BRIARGROVE SUBDIVISION, PHASE TWO

APPLICATION NUMBER 5 DATE June 7, 2012

REQUEST Subdivision

DETAIL SITE PLAN

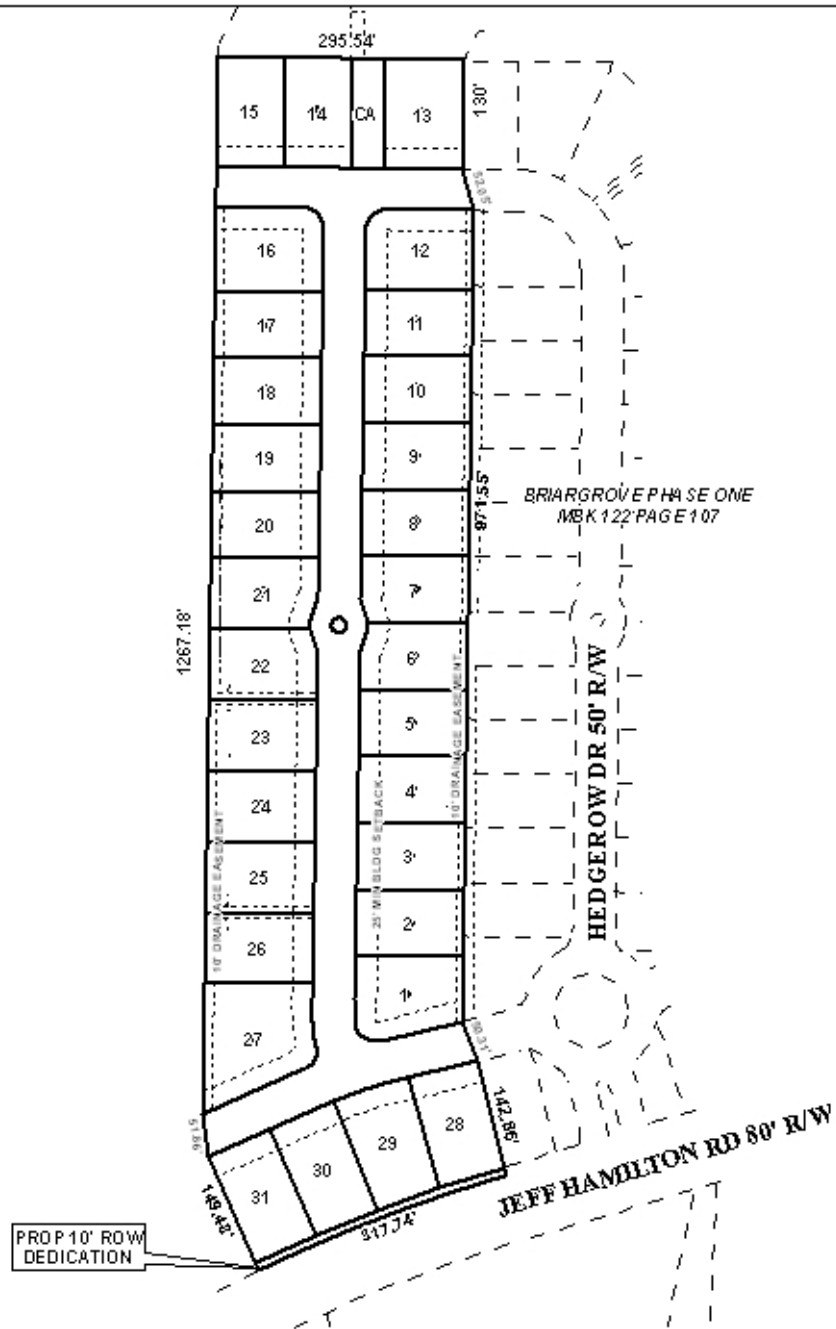
The plat illustrates the proposed 31-lot, 10.0± acre subdivision, which is located on the North side of Jeff Hamilton Road, ½ mile± West of Repoll Road extending to the West termini of Arbordale Drive and Hedgegrow Drive North., and is located within the Planning Jurisdiction. The applicant states that the subdivision is served by both public water and sanitary sewer.

The site fronts Jeff Hamilton Road, a planned major street having an existing right-of-way of 80-feet. The Major Street Plan, a component of the Comprehensive Plan requires a minimum 100-foot right-of-way; therefore, the dedication of sufficient right-of-way to provide 50-feet from the centerline of Jeff Hamilton Road would be required.

The application proposes new streets, which must be constructed and to Mobile County Engineering standards and dedicated to Mobile County prior to signing the Final Plat. Due to the location of Lots 28-31, they should be denied direct access to Jeff Hamilton Road. Further, as lots 1, 12, 16 and 27 are corner lots; therefore, a note should be placed on the Final Plat limiting each lot to one curb cut each, with the size, design and location to be approved by County Engineering.

The proposed 31-lot subdivision will have two connections to Briargrove, Phase One, and provide two street stubs to the undeveloped "Future Development" to the West.

Detention/retention and common areas are depicted on the preliminary plat; therefore, a note should be placed on the Final Plat stating maintenance of these areas will be the responsibility of the property owners.

The preliminary plat meets the minimum requirements of the Subdivision Regulations and is recommended for Tentative Approval subject to the following conditions:

- 1) dedication of sufficient right-of-way to provide 50-feet from the centerline of Jeff Hamilton Road;
- 2) the approval of all applicable federal, state and local agencies for wetlands prior to the issuance of any permits or land disturbance activities;
- 3) certification via placement of a note on the Final Plat stating that the property owner/developer will comply with all local, state and federal regulations regarding endangered, threatened or otherwise protected flora and fauna;
- 4) the placement of a note on the Final Plat stating that the development will be designed to comply with the storm water detention and drainage facility requirements of the City of Mobile storm water and flood control ordinances, and requiring submission of a letter from a licensed engineer certifying that the design complies with the storm water

- 5) the placement of a note on the Final Plat stating that Lots 28-31, be denied direct access to Jeff Hamilton Road and allowed one curb cut to the new street, with the size, design and location to be approved by Mobile County Engineering Department;

- 6) the placement of a note on the Final Plat stating that Lots 1, 12, 16 and 27 are limited to one curb cut each, with the size, design and location to be approved by County Engineering;

- 7) retention of the labeling of the lots with its size in square feet, or placement of a table on the plat with the same information;
- 8) the placement of a note on the Final Plat stating that any lots which are developed commercially and adjoin residentially developed property must provide a buffer, in compliance with Section V.A.7 of the Subdivision Regulations; and

- 9) placement of a note on the plat stating that maintenance of the detention and common areas is the responsibility of the subdivision's property owners.
